**Report to
Development Permit Panel**

To: Development Permit Panel
From: Joe Erceg
Manager, Development Applications
Date: August 6, 2003
File: DP 03-232824
Re: **Application by J.A.B. Enterprises Ltd. for a Development Permit at
7160 Blundell Road**

To: Development Permit Panel
From: Joe Erceg
Manager, Development Applications
Date: July 9, 2003
File: DP 03-232824
Re: Application by J.A.B. Enterprises Ltd. for a Development Permit at
7160 Blundell Road

1 SITE PLAN
SCALE: 1/8" = 1'-0"

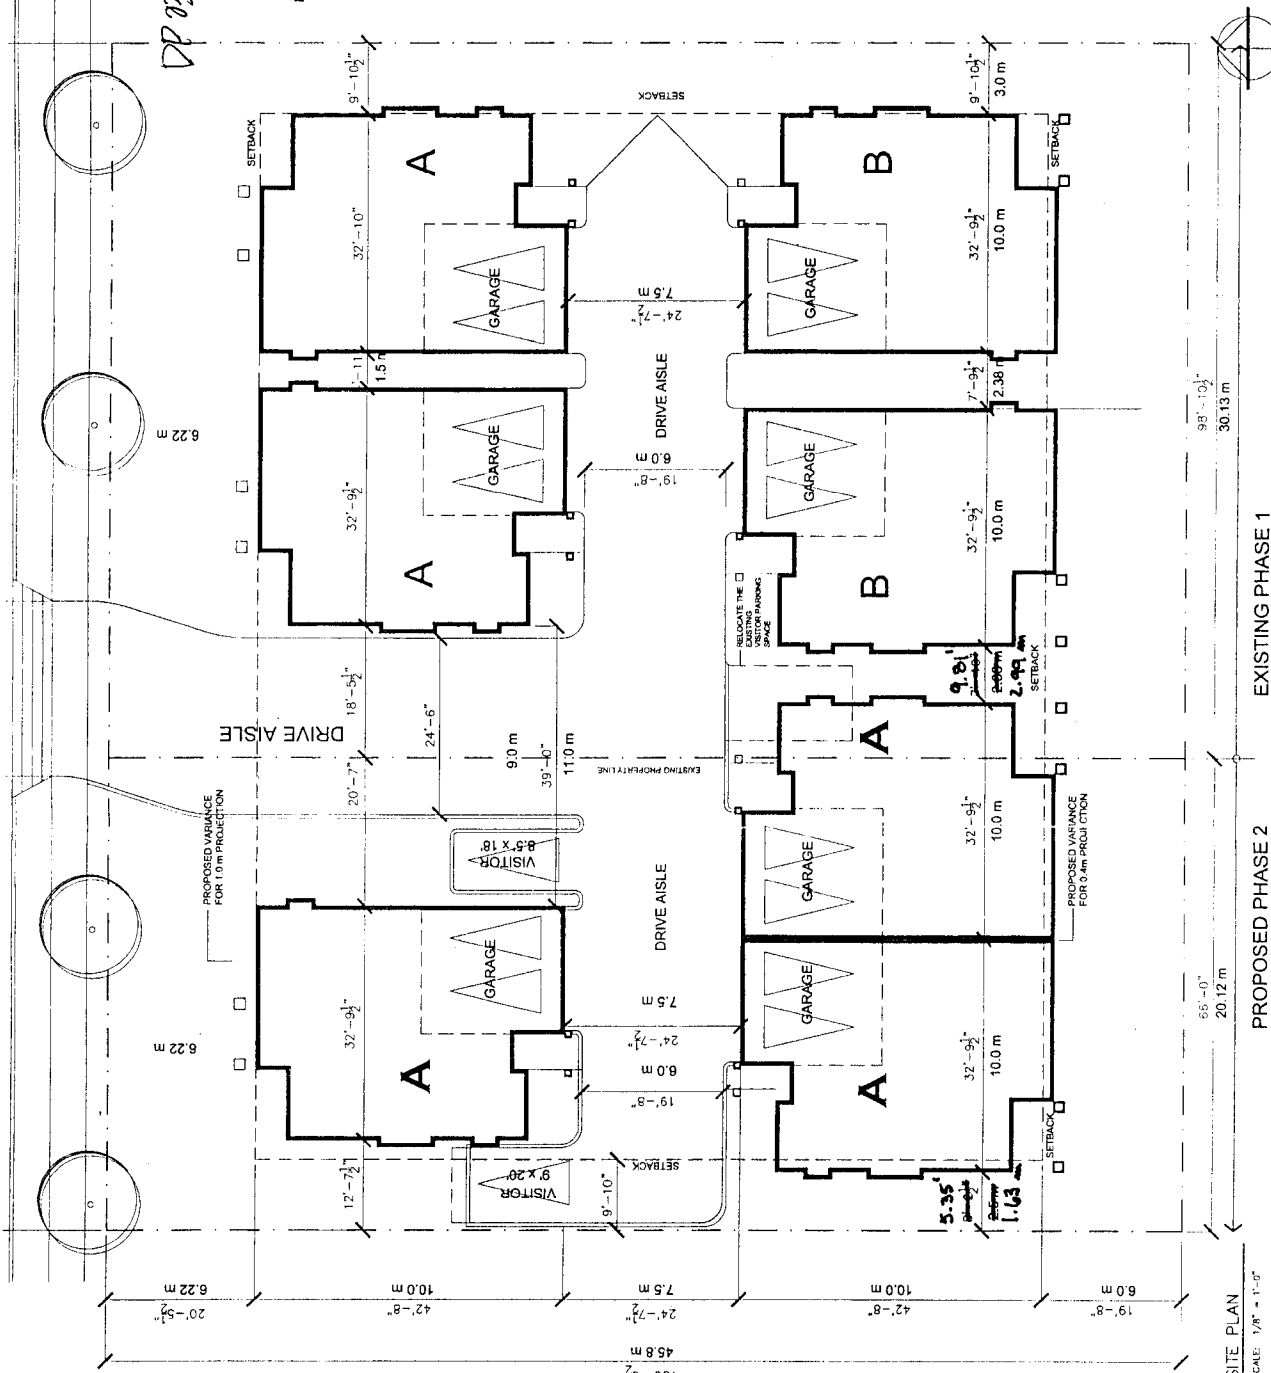
The revised request is to vary the side yard setback along the western property line from 3 m (9.843 ft.) to 1.63 m (5.35 ft.) for a portion of the principal building and to 1.32 m (4.34 ft.) for a 2-storey box bay window and gas fireplace on the one (1) townhouse unit at the southwest corner of the site.

The reason for this change is because the building containing the two (2) southerly townhouses has been shifted further to the west. This has been done in order to accommodate a Building Code requirement that the distance between buildings be more than 2.438 m (8 ft.) - otherwise no openings would be permitted along the wall between this building and the townhouse to the east.

6. The driveway access to Blundell Road is a temporary access and the intention is to eventually retire this driveway access when the long-term east-west laneway is completed. The applicant was requested to provide a long-term site plan and landscape plan to illustrate the eventual elimination of the temporary access route to Blundell Road. As part of these changes to the site plan, it was recommended that the applicant relocate the two (2) visitor parking stalls along the west property line to the approximate location of the temporary driveway alignment in this future reconfiguration of the site plan. It was also suggested that the applicant eliminate the refuse/recycling enclosure. *Complies, and a revised landscape drawing has been submitted.*

LANDSCAPE PLAN

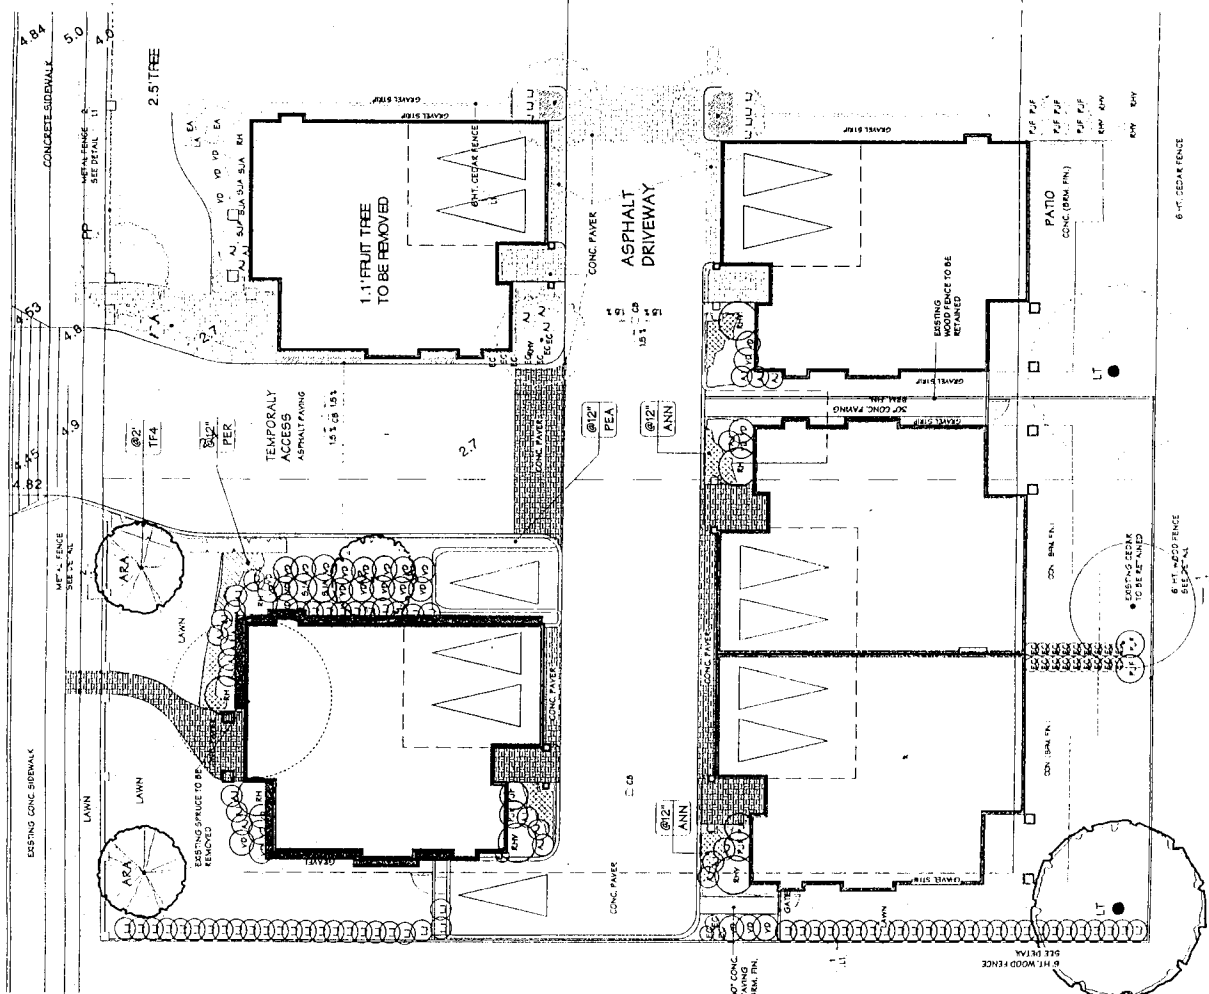
The applicant has also revised the landscape plan to include a hedge along the southwestern property line in order to improve the buffer between the townhouse unit with the side yard setback variance and the single-family residential lot to the west.

West Property Line: Along the west property line, the applicant has requested setback variances for the townhouse unit in southwest corner of the site. The applicant was requested to remove the visitor parking stall in this location in order to provide additional landscape screening and buffering for the adjacent single-family dwelling. The applicant has relocated the visitor parking stall and currently proposes a 1.5 m (6 ft.) high wood fence on the property line with minimal hedging along this portion of the east property line.

The applicant proposes to remove 1 existing spruce tree that is greater than 15cm (6") in caliper size and the applicant has been requested to provide 2 replacement trees at 10cm (4") in caliper. The has not agreed to provided tree replacement according the City of Richmond guidelines. The applicant has requested side yard setback variances but has provided little landscape screening and buffering to mitigate the impacts of the requested side yard setback variances. Richmond staff have concerns regarding the lack of tree replacement and the minimal landscape screening along the west property line in the vicinity of the requested setback variance.
